Modification Application

NEVERTIRE SOLAR FARM

SEPTEMBER 2017

Project File Name: Nevertire solar Farm Modification Report

- A. 1 Comparison of EIS, Submissions Report and Modification Layout**
- A. 2 Modification Layout (proposed to replace that shown in the consent)**

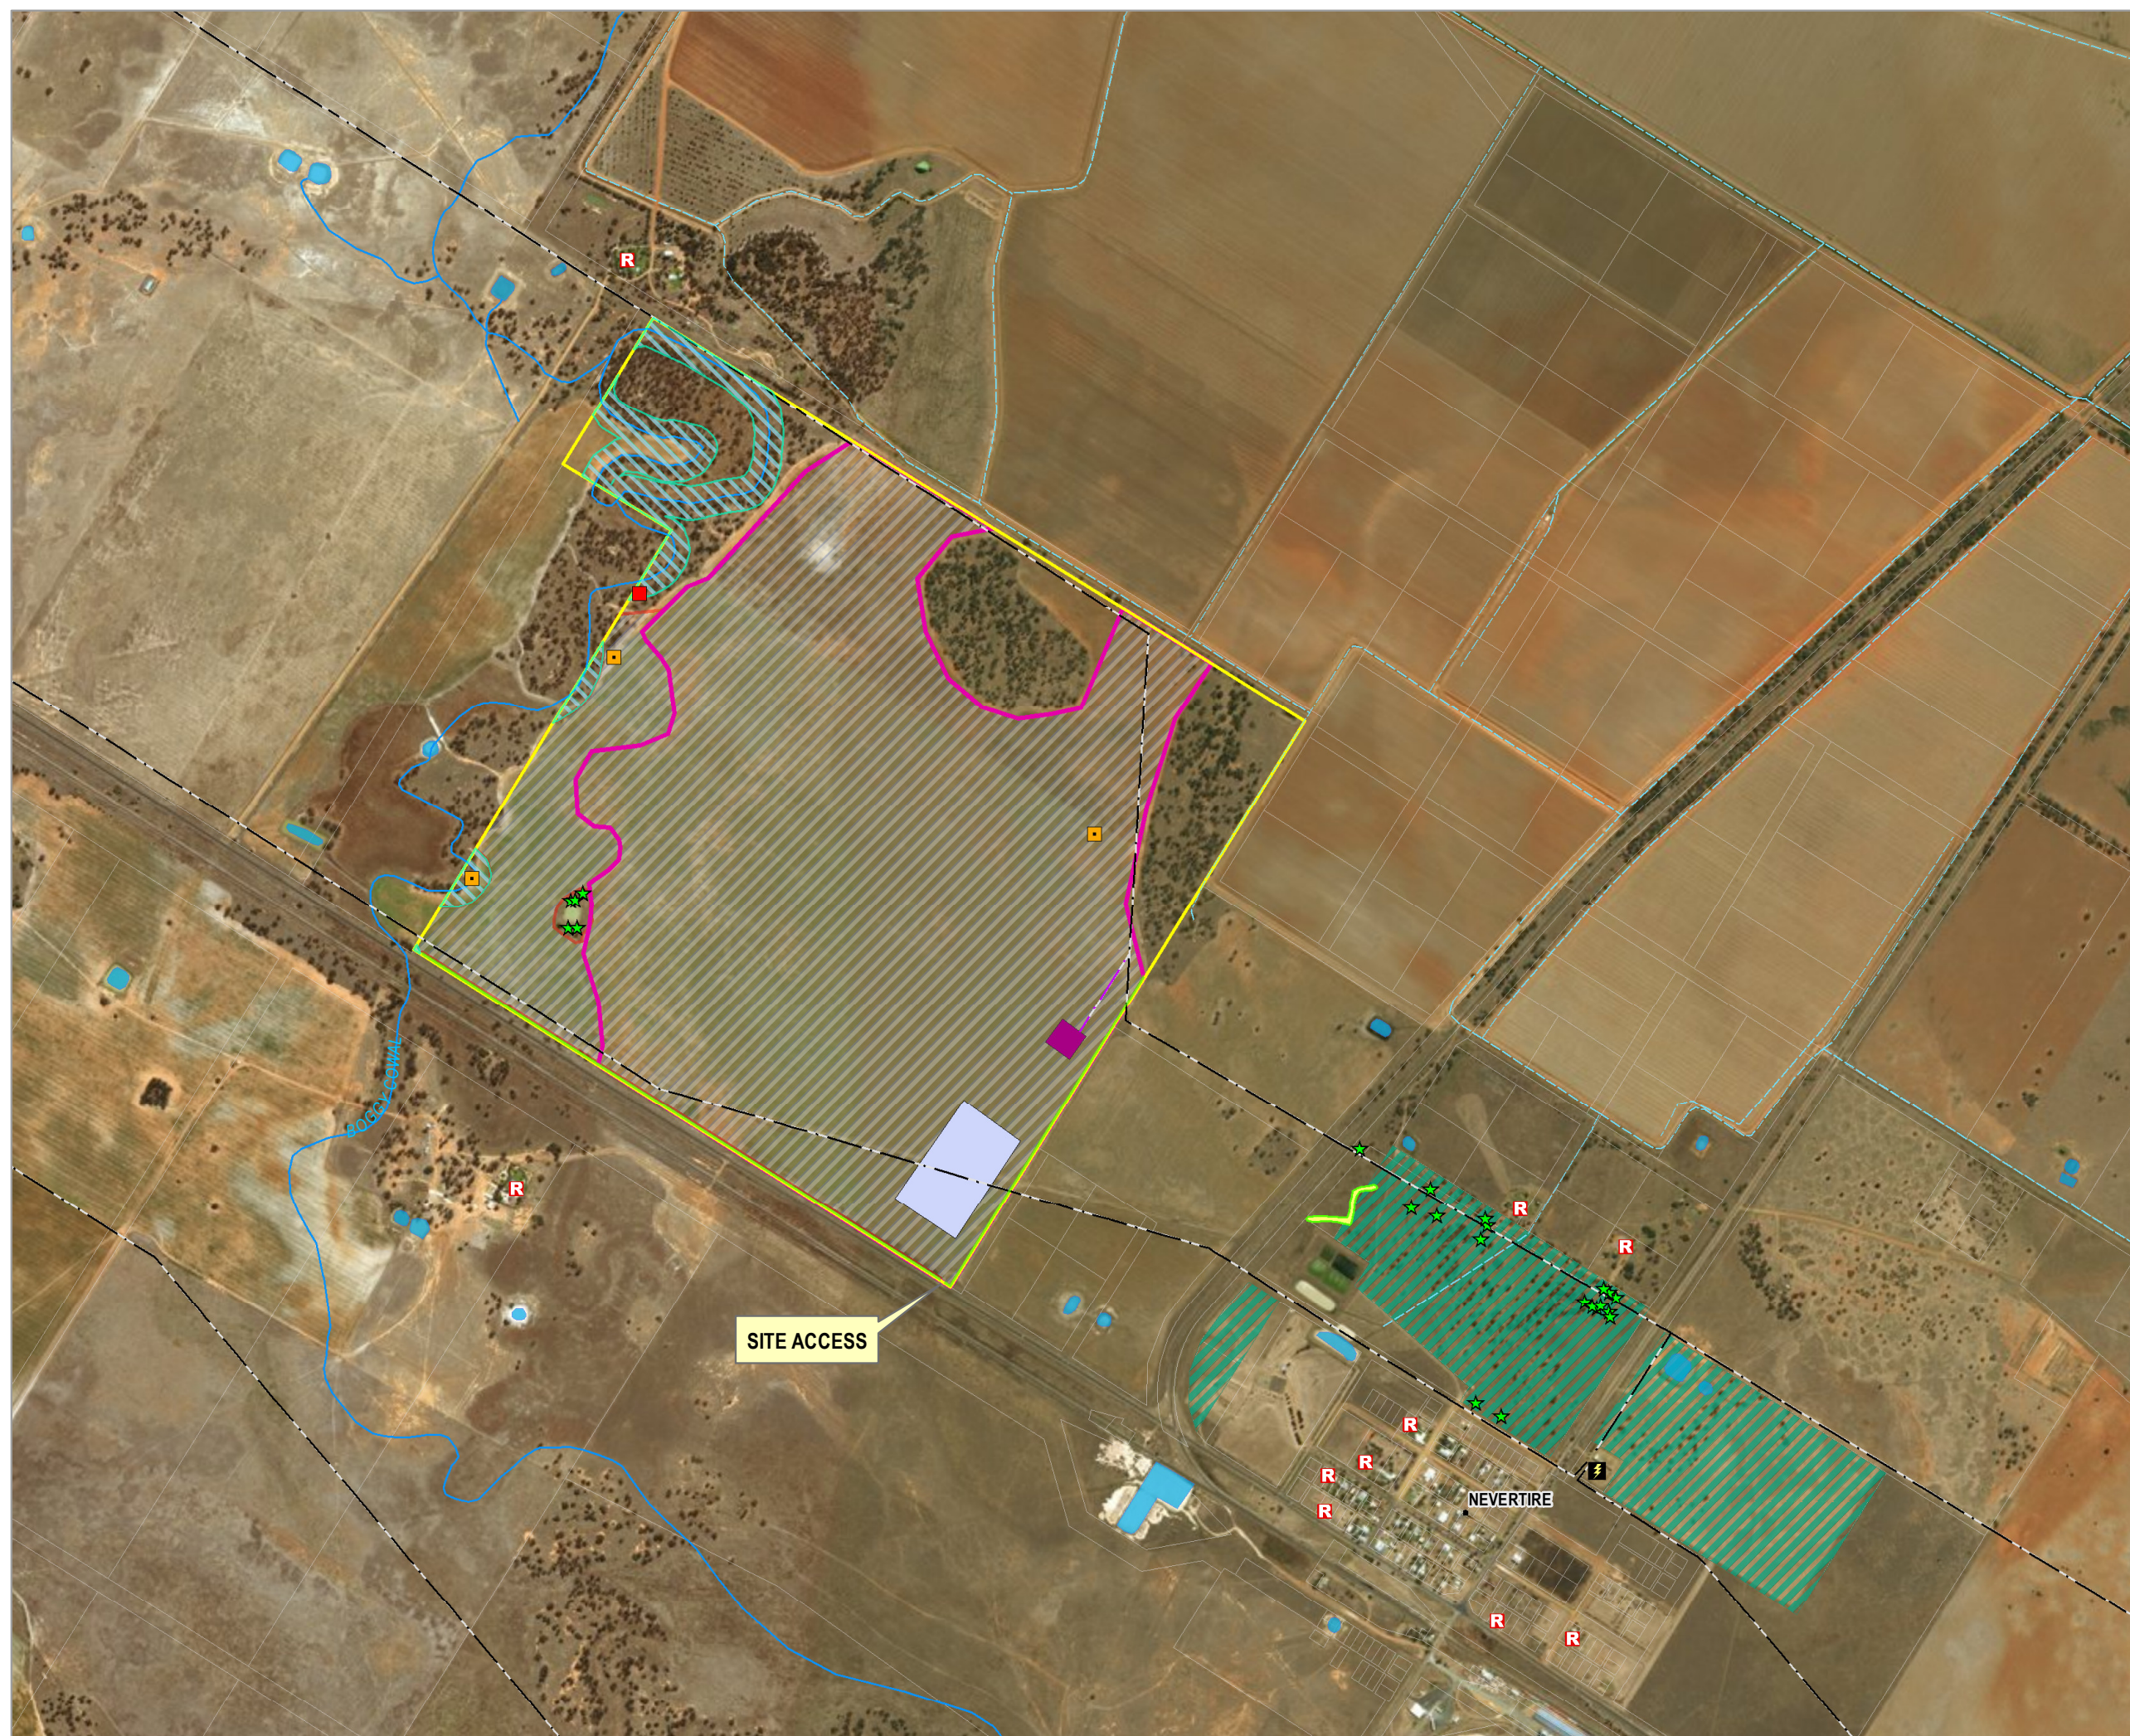
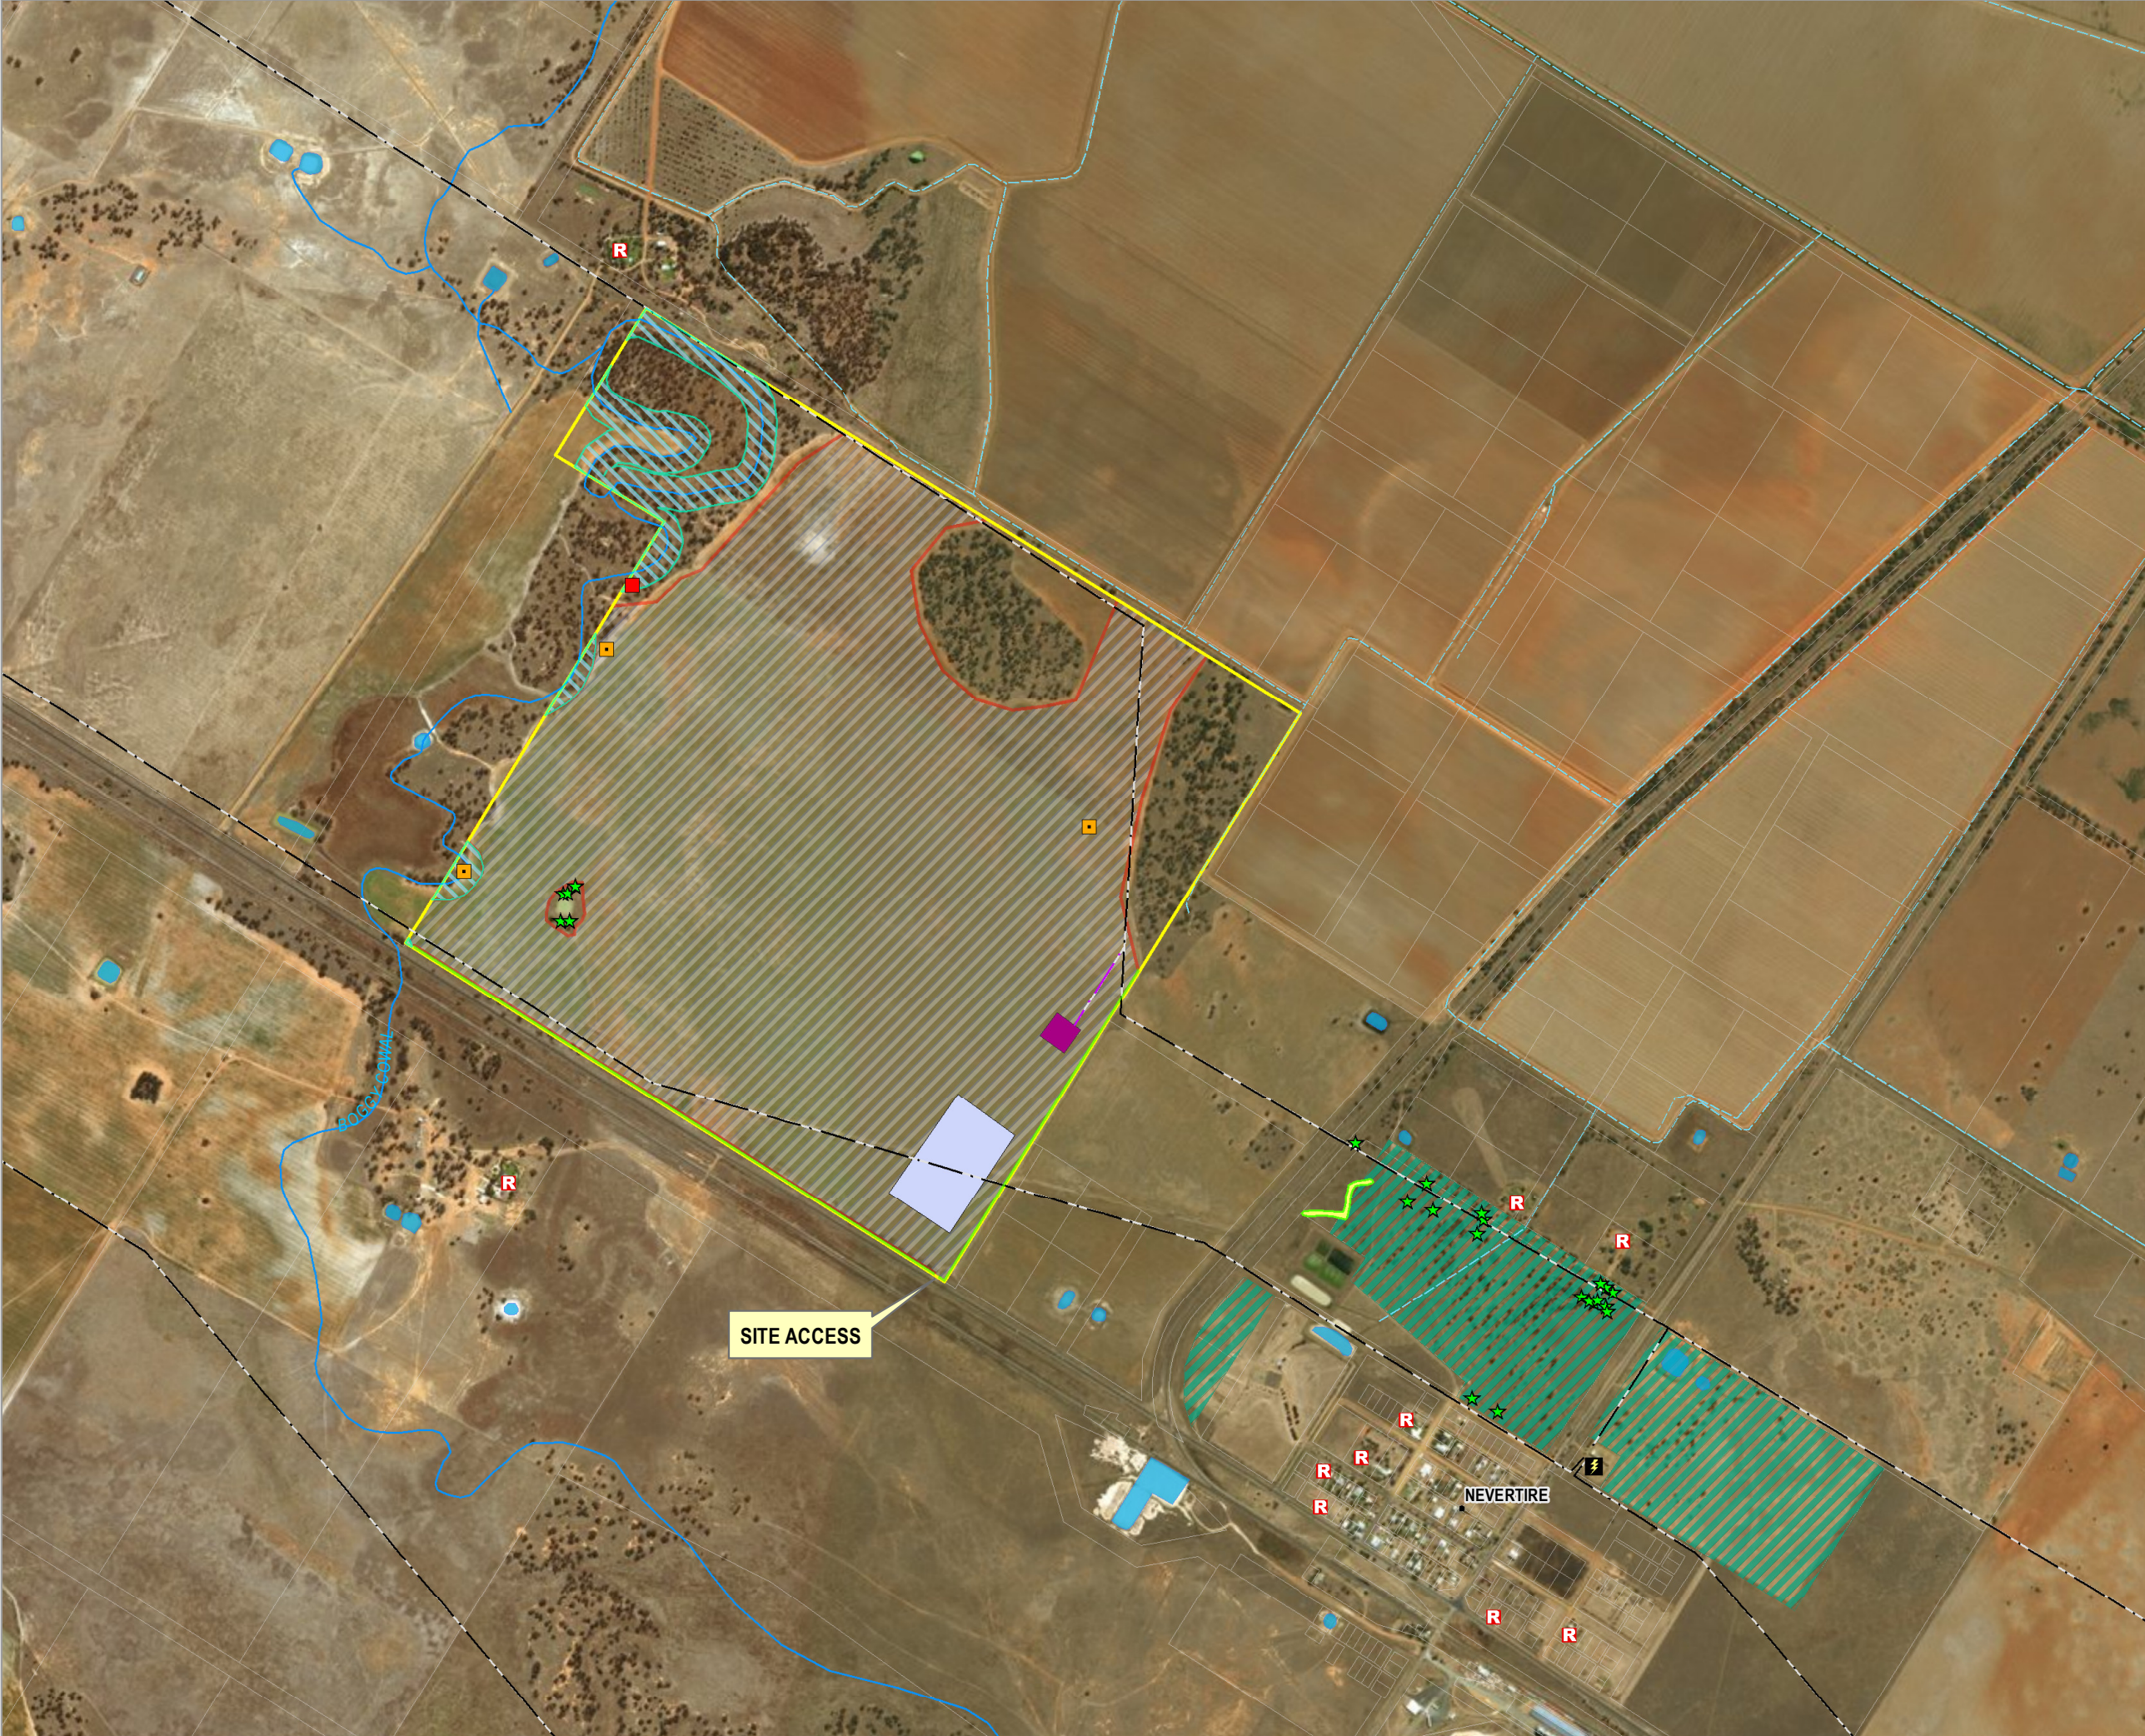
The modified solar farm development footprint is illustrated in Appendix A in comparison to the approved footprint.

The modification proposed is to expand the solar farm development footprint into the south-western portion of the site. The development footprint would increase from the approved 177 ha to approximately 200 ha.

The proposed modification layout lies between these two layouts, but is closer to that presented in the EIS. It now includes all potential Sloane's froglet habitat in the south-western portion of the site, but avoids the dam and native vegetation surrounding the dam. Therefore, the modification development footprint has an increased level of impact than that presented within the Submissions Report and Development Consent. However, the modification development footprint has an equivalent or marginally reduced level of impact compared to the publicly exhibited EIS., approximately 0.83 ha.

The development footprint provided in the Development Consent would require an update based on the modified layout (provided in this Modification Report in Appendix A) in order to make the modification compliant.
